Work Order ID 105214

Item Name: Crosstube Assembly, Mid Aft

DART AEROSPACE LTD		Work Order: 105214
Description: Crosstube Assembly, Mid Aft		Part Number: D206-667-247TRN
Inspection Dwg: D206-667-247 Rev: A		Page 1 of 2

DRAWING NO. D206-667-247	TITLE CROSSTUBE ASS'Y (206L MID AFT)	REV. A	DART AEROSPACE LTD ENGINEERING ORDER		D.E.O. NO. D206-667-247-A-1	SHEET NO. SHEET 1 OF 1	SCALE NTS
DRAWN 90	CHECKED ASS	MFG. APPR. KDS	APPROVED JMD		DE APPR. H		
DATE 11.07.15	DATE 11.07.20	DATE 11.07.21	DATE 11/07/21		DATE 11.07.21

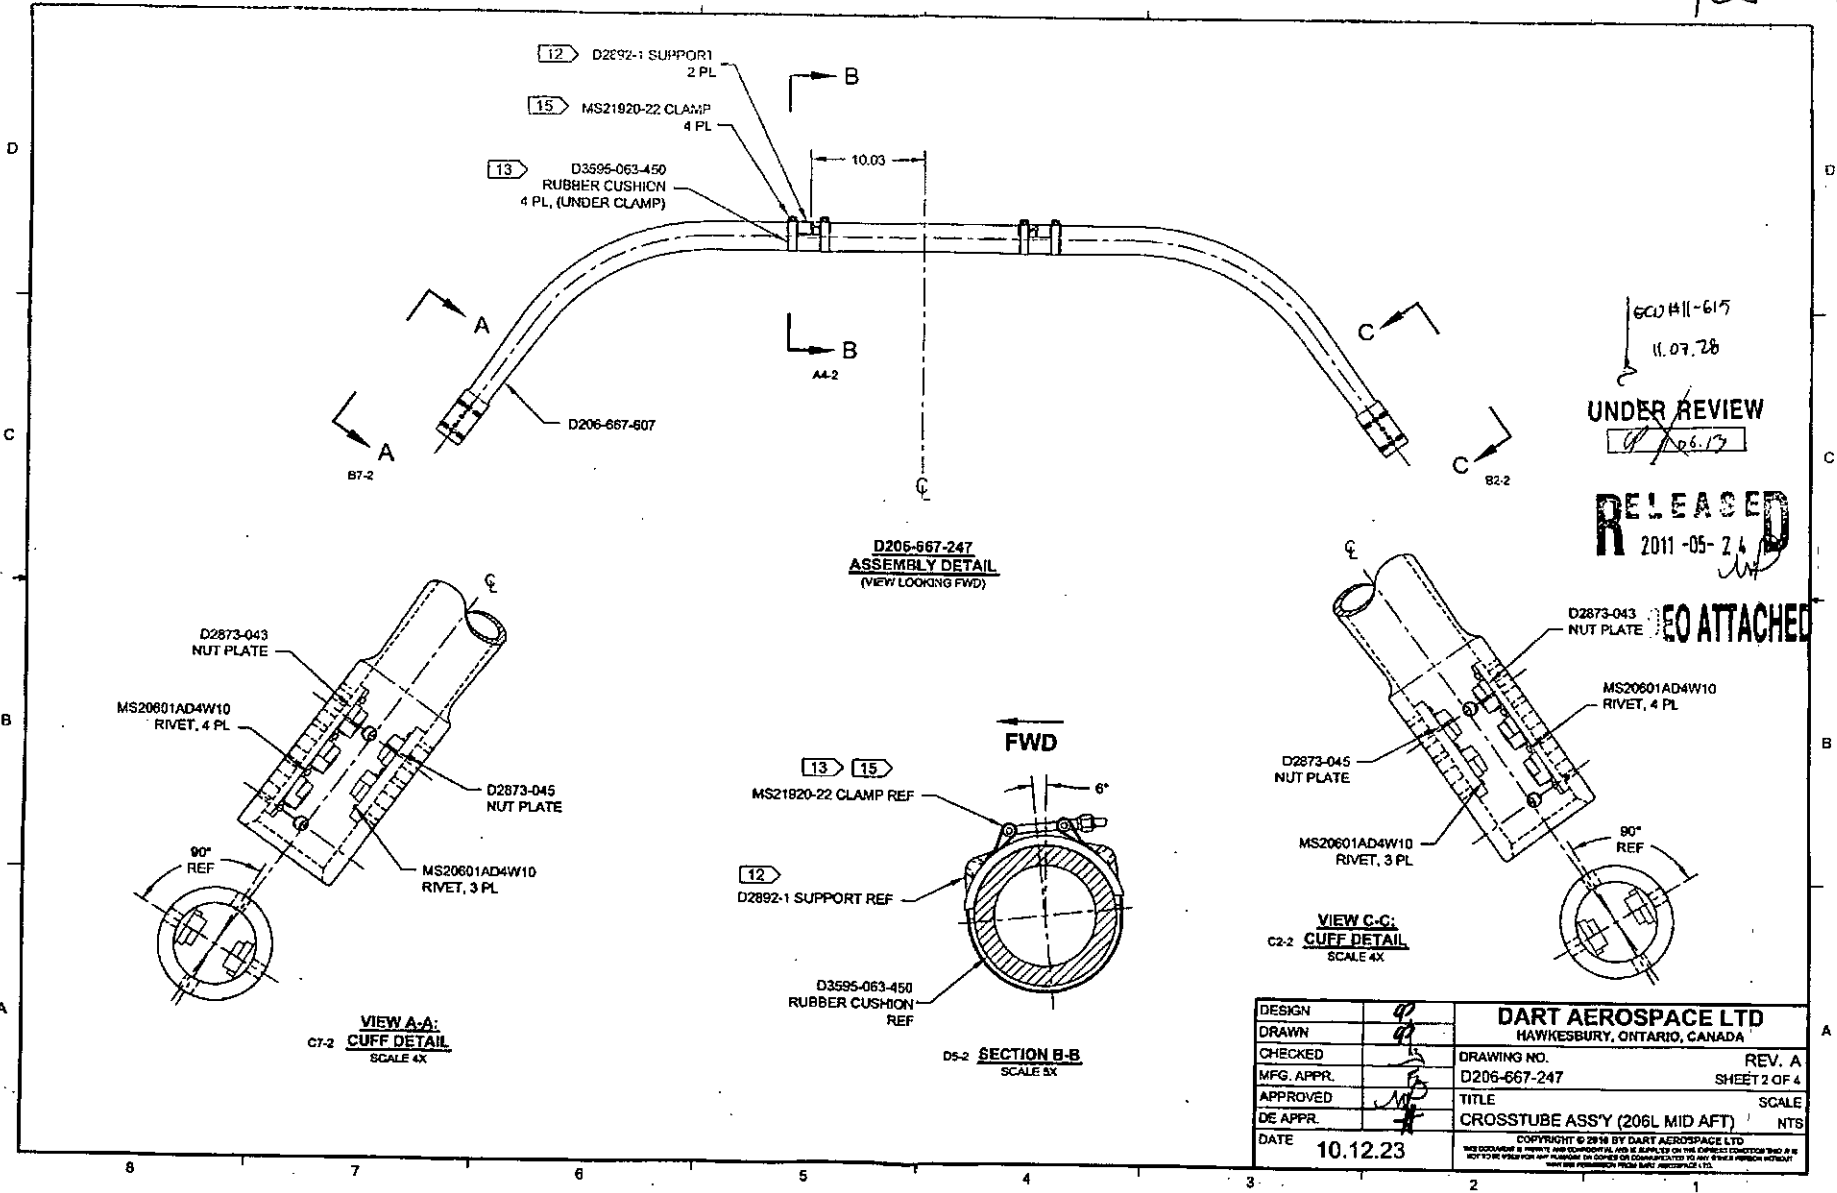
PURPOSE:

REPLACE MAGNOBOND WITH PROSEAL

NOTE 12 & 15, SHEET 1 IS AMENDED AS FOLLOWS:

Item	Qty -247	Part Number	Description
9	A/R	PROSEAL 890 B-2	SEALANT, AMS-S-8802 CLASS B-2

- 12) TO INSTALL D2892-1 SUPPORT: ABRASE MATING SURFACE OF SUPPORT AND CROSSTUBE WITH 180-GRIT SANDPAPER AND REMOVE RESIDUE WITH MEK (OR EQUIVALENT). APPLY A 0.04" TO 0.07" THICK LAYER OF PROSEAL 890 CLASS B-2 (OR AMS-S-8802 CLASS B-2) SEALANT TO MATING SURFACE OF SUPPORT.
- 15) TORQUE CLAMPS 80 TO 100 IN-LB. ENSURE AT LEAST 1.5 THREADS SHOWING IN SAFETY AND THAT NUT HAS NOT BOTTOMED-OUT AFTER TORQUING. **PRIOR TO PACKAGING, RE-CHECK TORQUE ON CLAMPS AFTER PROSEAL 890 SEALANT HAS CURED FOR 72 HOURS.**
